HISTORIC AND DESIGN REVIEW COMMISSION

June 19, 2019

HDRC CASE NO: 2019-328
ADDRESS: 3903 N ST MARYS, San Antonio Zoo
3015 BROADWAY
LEGAL DESCRIPTION: Public Property
NCB 6298 BLK 4 LOT 145 THRU 150
ZONING: R-6, HS, C-2, RIO-1, PUBLIC PROPERTY
CITY COUNCIL DIST.: 1,2
LANDMARK: Brackenridge Park
APPLICANT: Ryan Schmidt
OWNER: ARW Kiddie Park Land, LP
TYPE OF WORK: Relocation of Kiddie Park to the San Antonio Zoo
APPLICATION RECEIVED: May 17, 2019
60-DAY REVIEW: July 16, 2019
CASE MANAGER: Edward Hall
REQUEST:

KIDDIE PARK RELOCATION TO THE SAN ANTONIO ZOO

MAIN ENTRY GATE ELEVATION

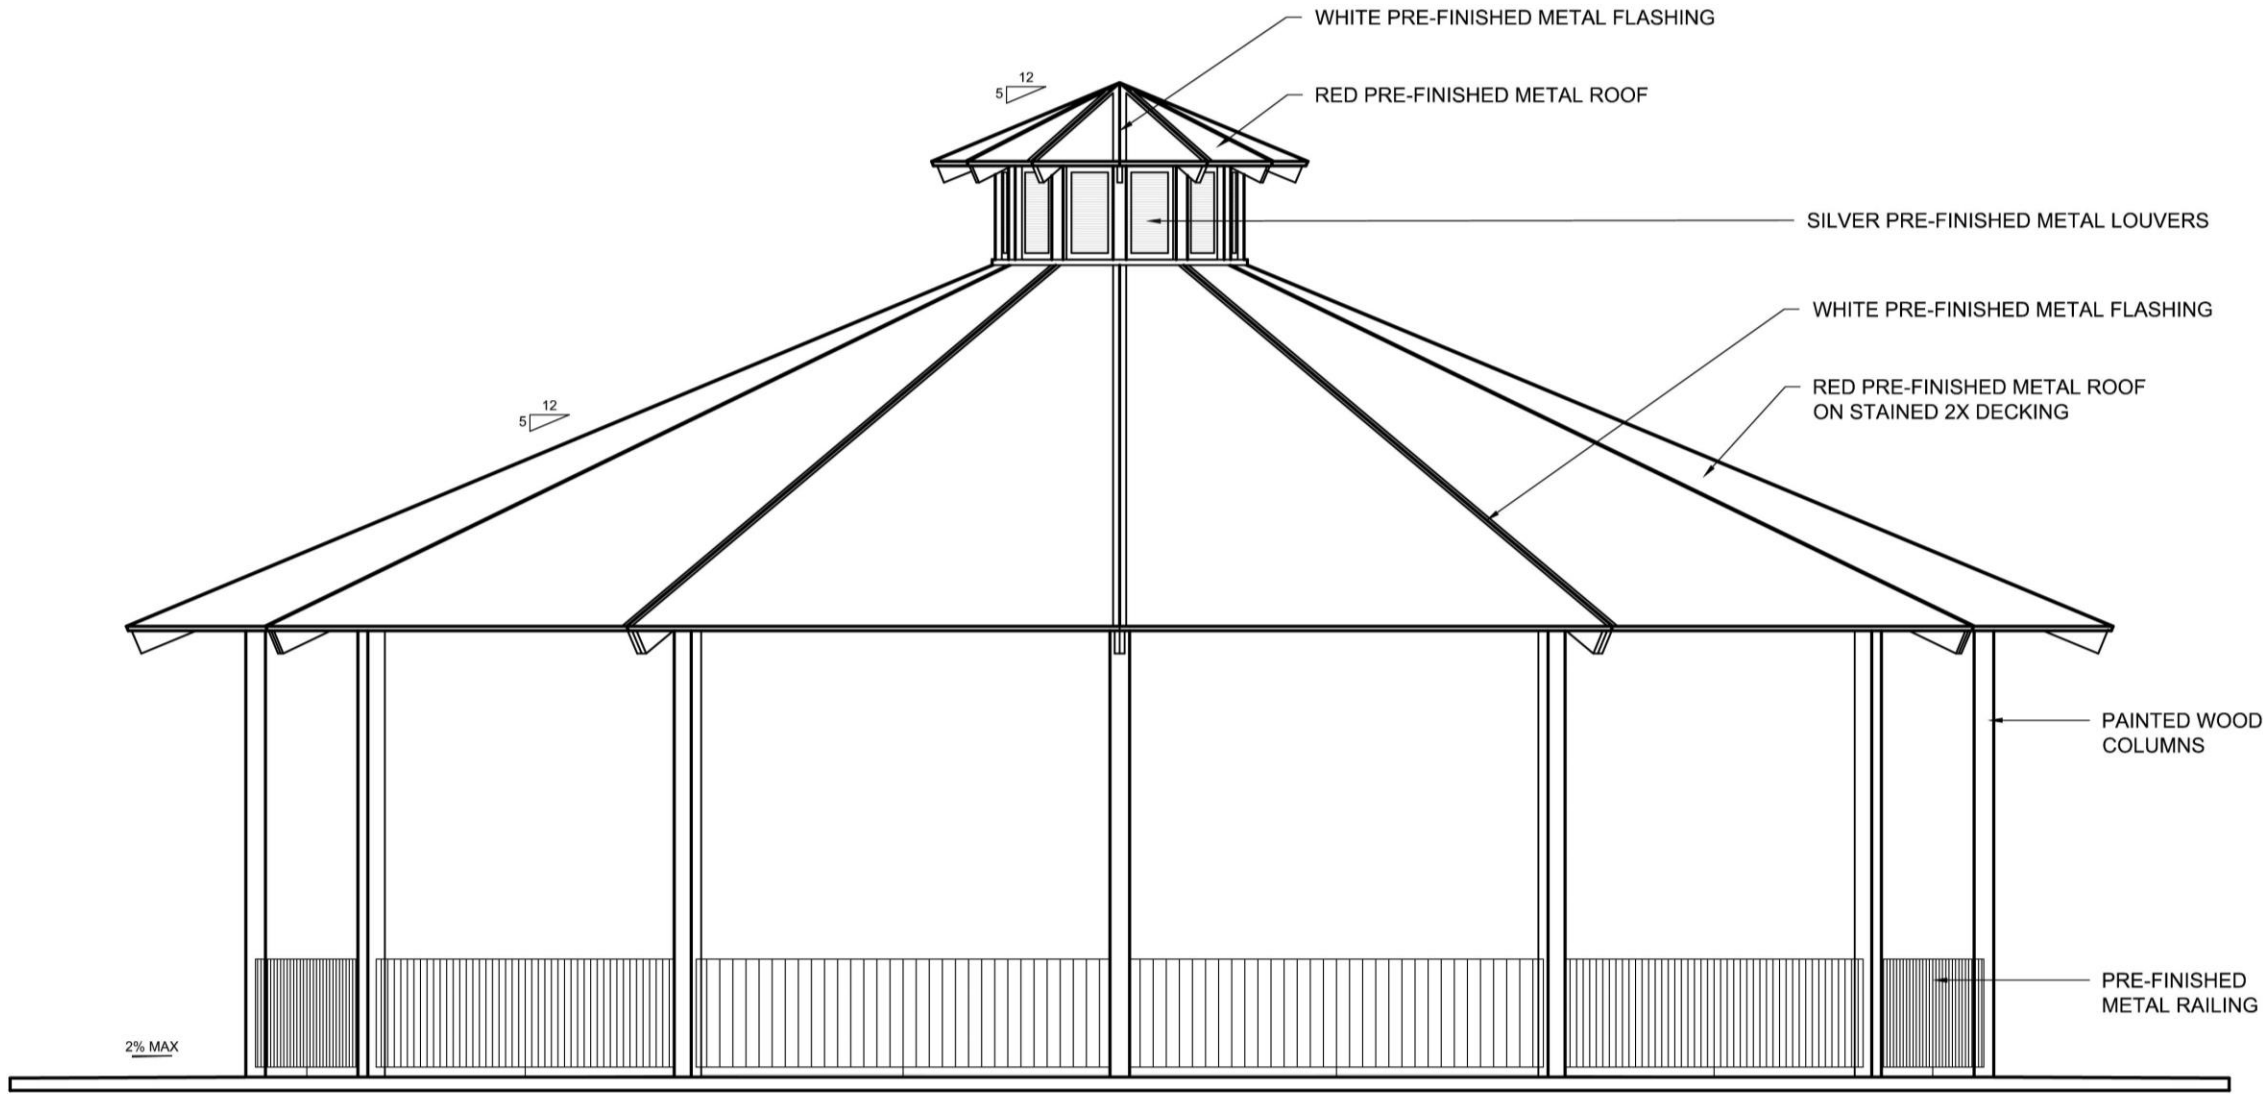
The entry gate will be recreated to match the Broadway site. Gates, arched sign, and flagpoles will be reused and look the same as before. Matching limestone will be used to recreate the bases. See drawing below and reference photo of entry gate in Part 1.

Proposed Gravel

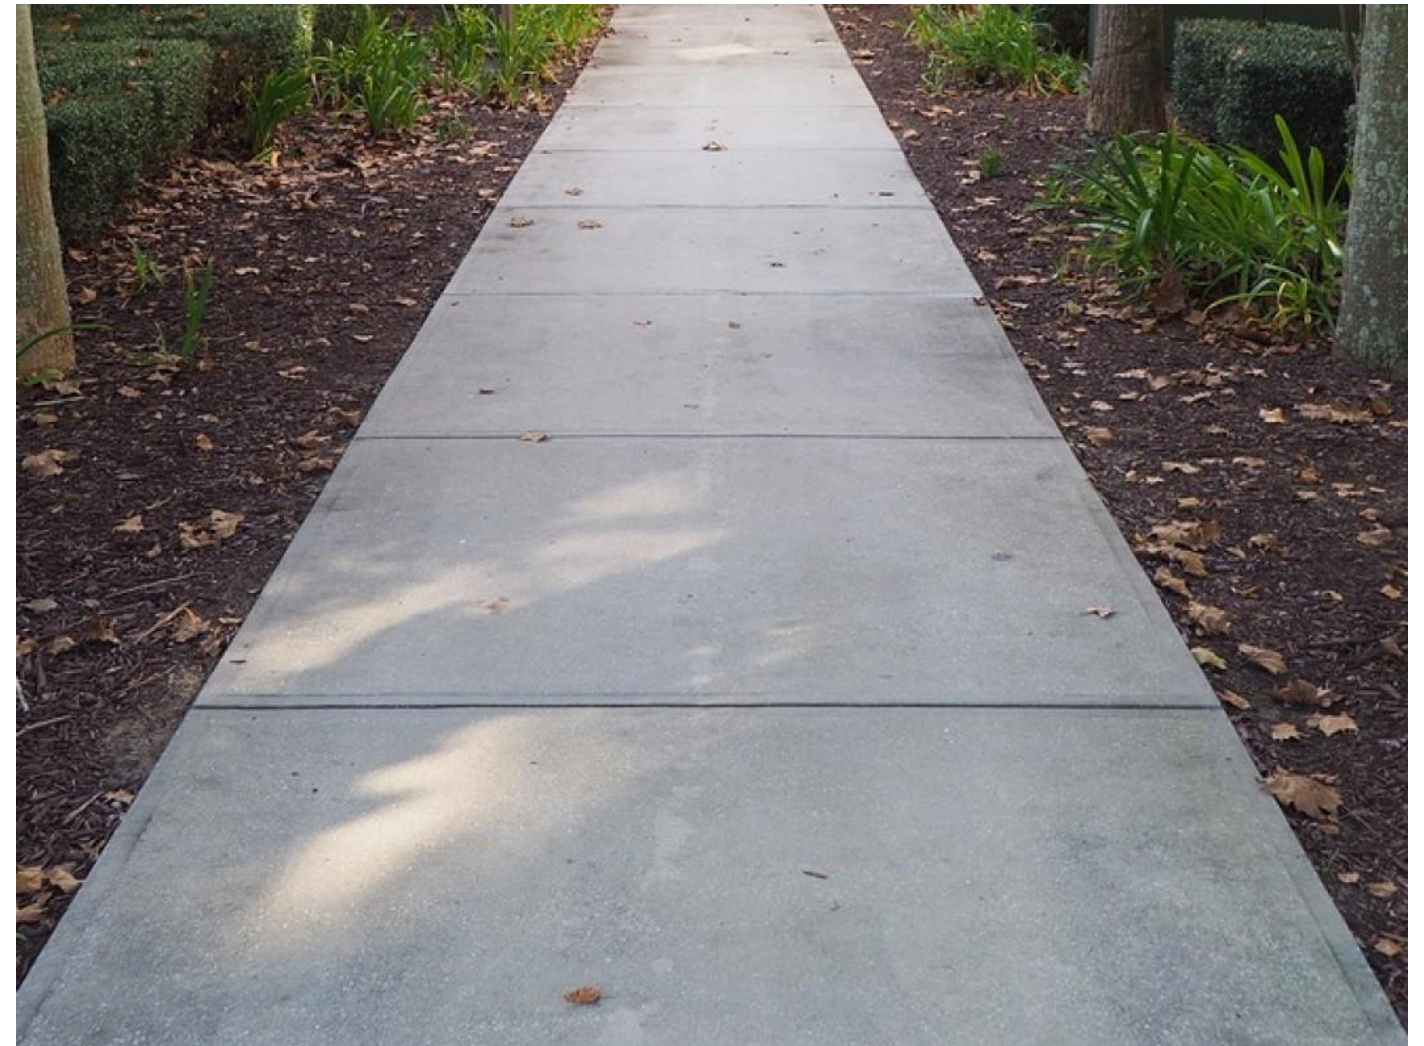
- g. PAVING – The applicant has proposed to use the existing parking lot as a base level and install concrete walkways and decorative gravel fill. Staff finds this to be appropriate.
